**ADDENDUM NO. 1
YOUTH BASEBALL COMPLEX RENOVATION - FIELDS 11 & 12
MANDAN PARK DISTRICT
MANDAN, NORTH DAKOTA**

BID DATE: February 11, 2026

YOUTH BASEBALL COMPLEX RENOVATION FIELDS 11 AND 12 MANDAN PARK DISTRICT MANDAN, NORTH DAKOTA

SPOT ELEVATION PLAN - FIELD 12

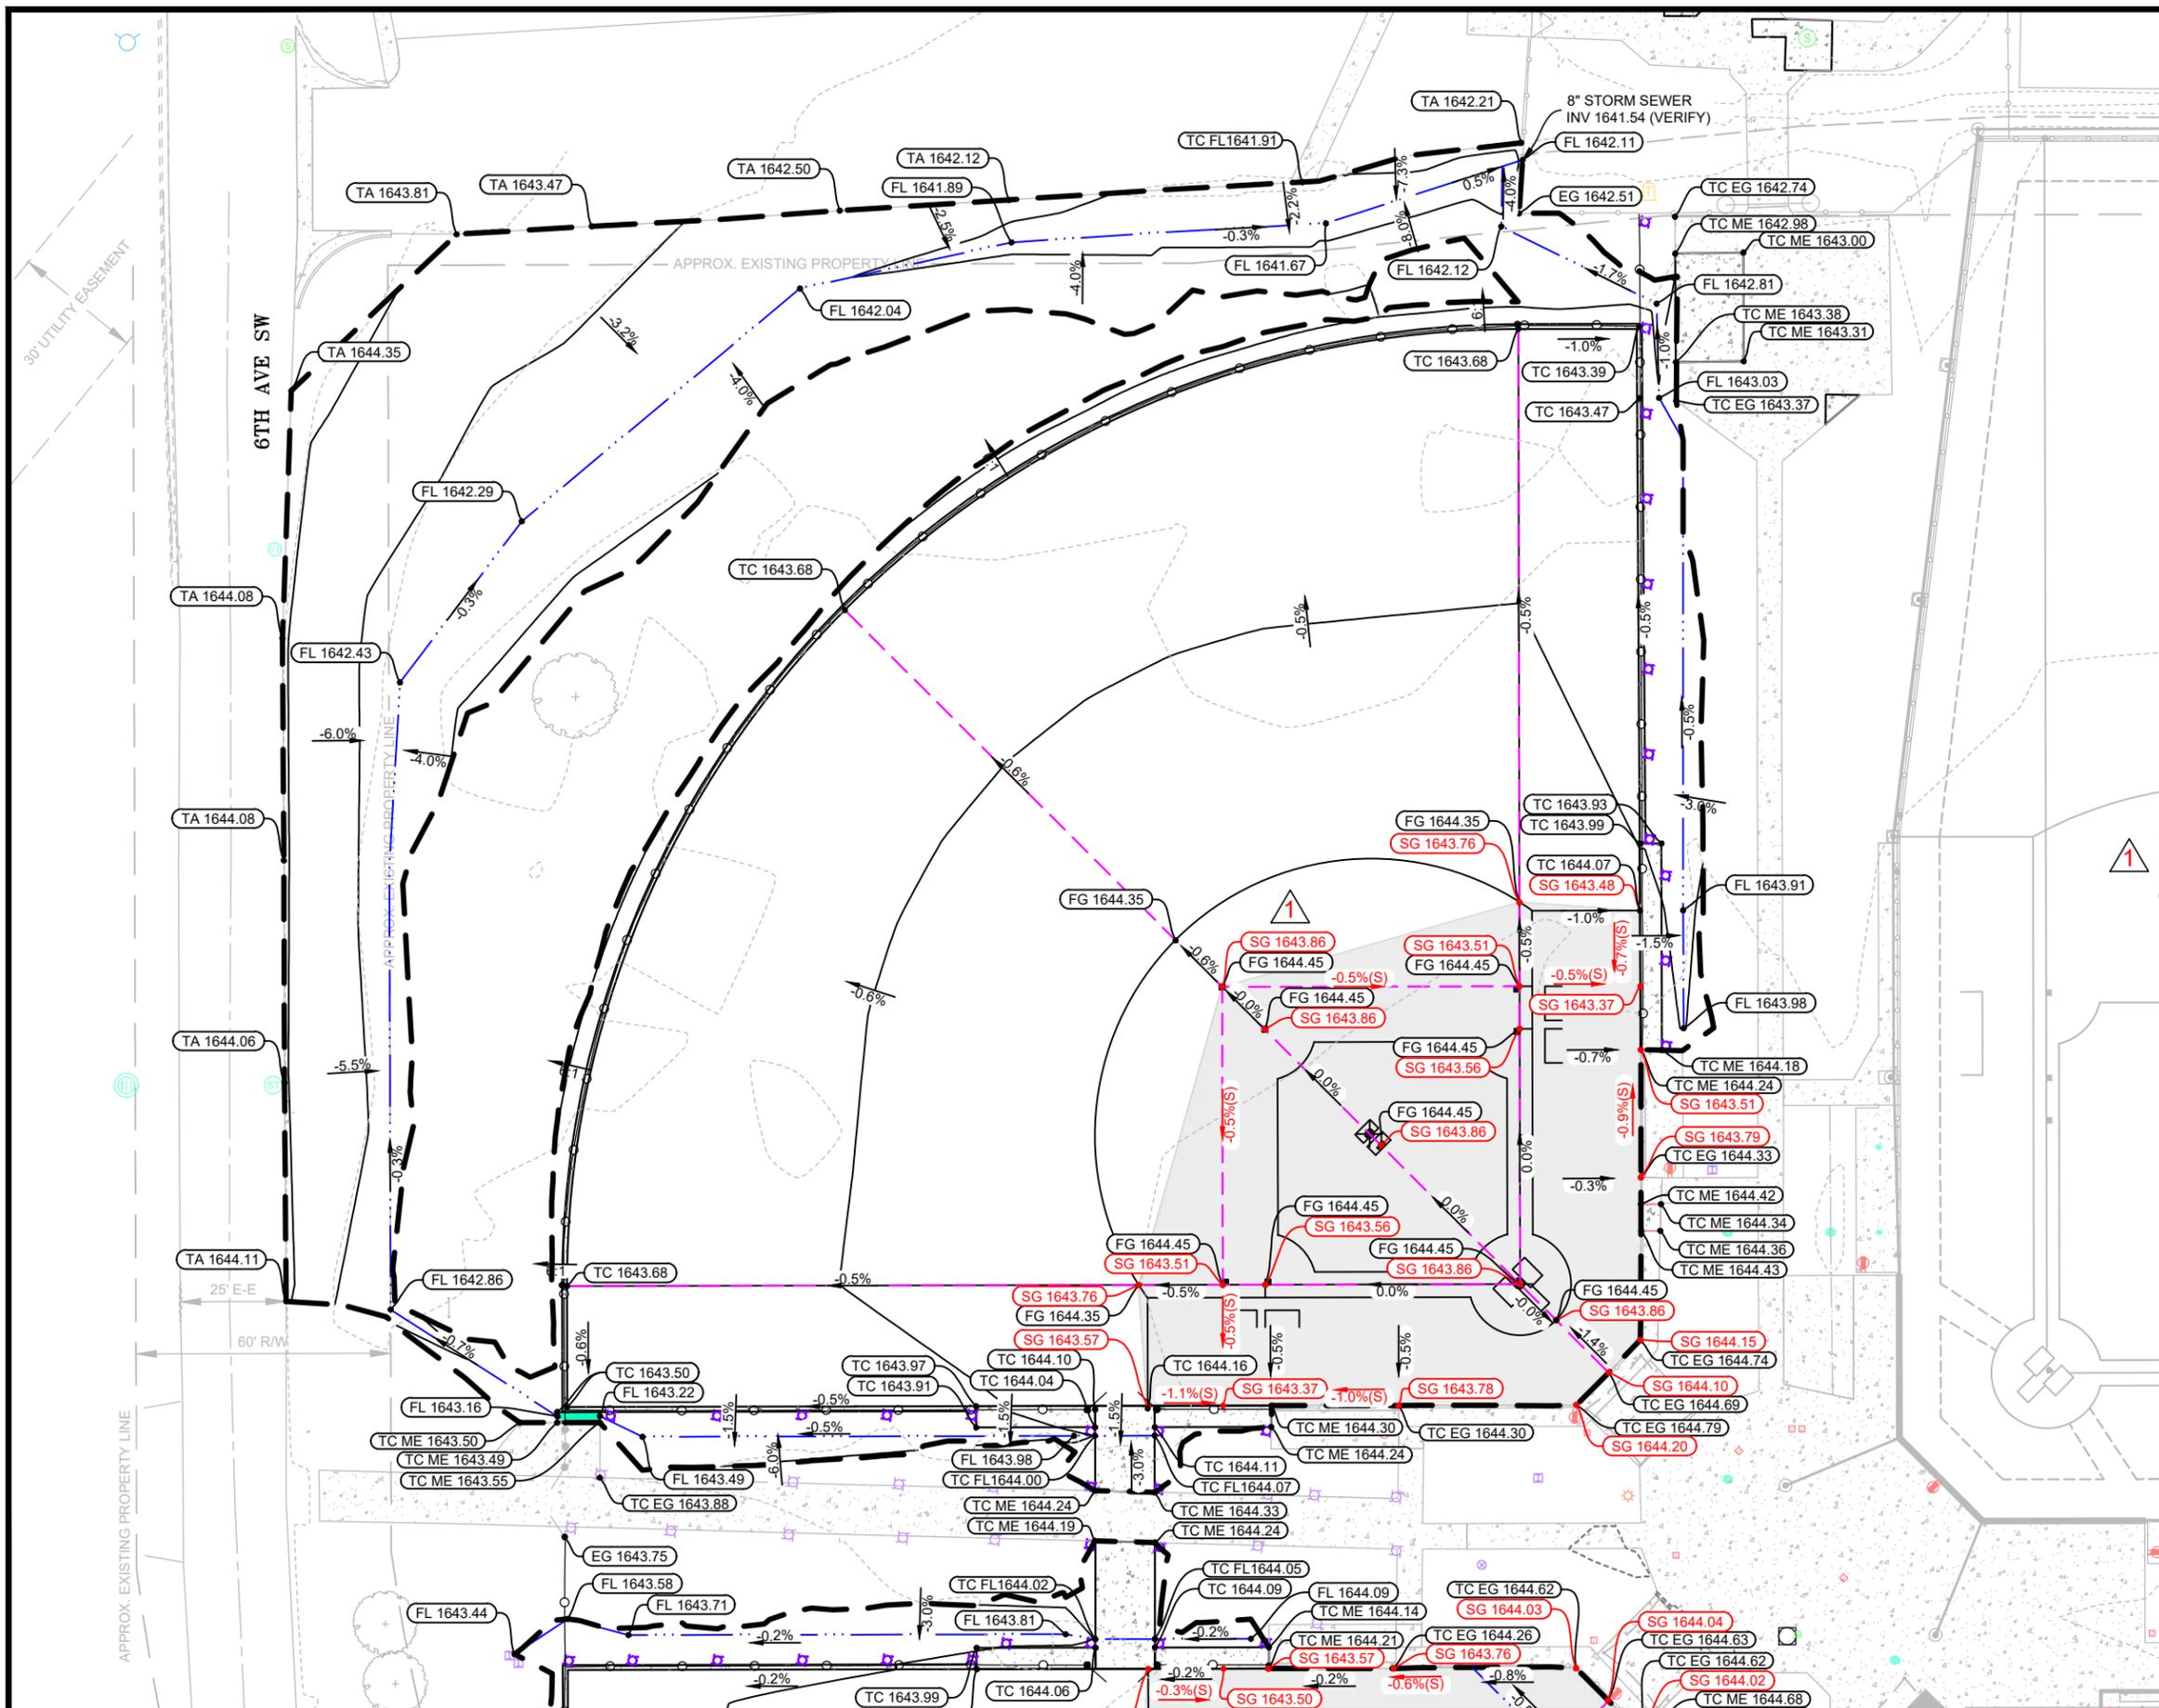
e. C5.2 - Spot Elevation Plan - Field 12

- i. Provided top of subgrade (bottom of base stone) elevations for infield.

4 C6.7 BASE STONE (TRENCHES & INFIELD SUBGRADE SLOPE)
NOT TO SCALE

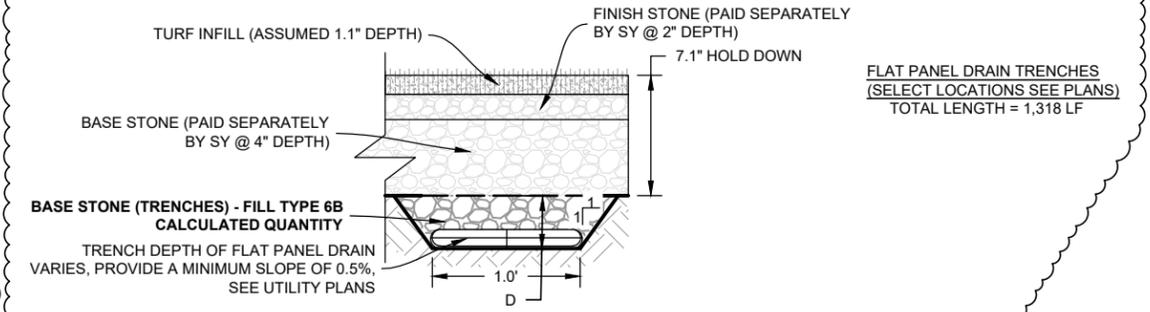
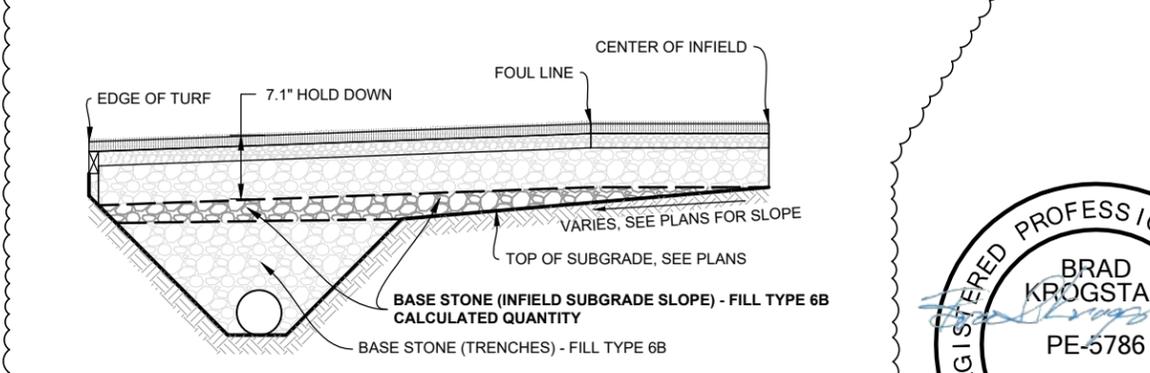
f. C6.1 - Site Details

- i. Added detail 4/C6.1 "Base Stone (Trenches & Infield Subgrade Slope).

6 SIDEWALK TRENCH & GRATE
NOT TO SCALE

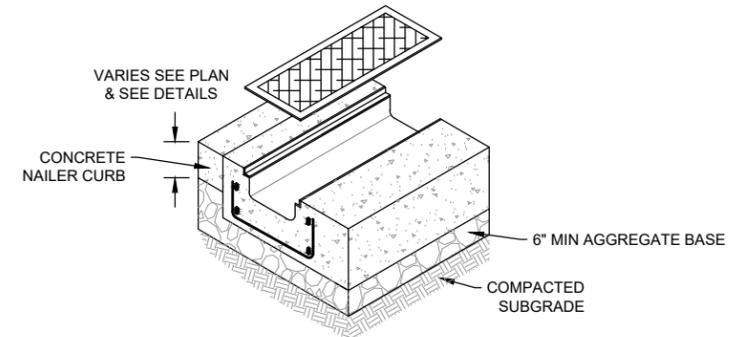
g. C6.2 - Site Details

- i. Added Note "2. Concrete for the trench drain shall be included in the bid item Sidewalk Trench Drain." on detail 6/C6.2 - Sidewalk Trench & Grate.

- TRENCH GRATE FRAME AND COVER SHALL BE NEENAH R-4990-CX WITH A TYPE D SOLID LID COVER OR AN APPROVED EQUAL. GRATE AND COVER SHALL BE INSTALLED ACCORDING TO MANUFACTURER'S SPECIFICATIONS. SUPPORT BRACES SHALL BE INSTALLED ONE AT EACH END AND 2' CENTER TO CENTER THEREAFTER.
- CONCRETE FOR THE TRENCH DRAIN SHALL BE INCLUDED IN THE BID ITEM "SIDEWALK TRENCH DRAIN."
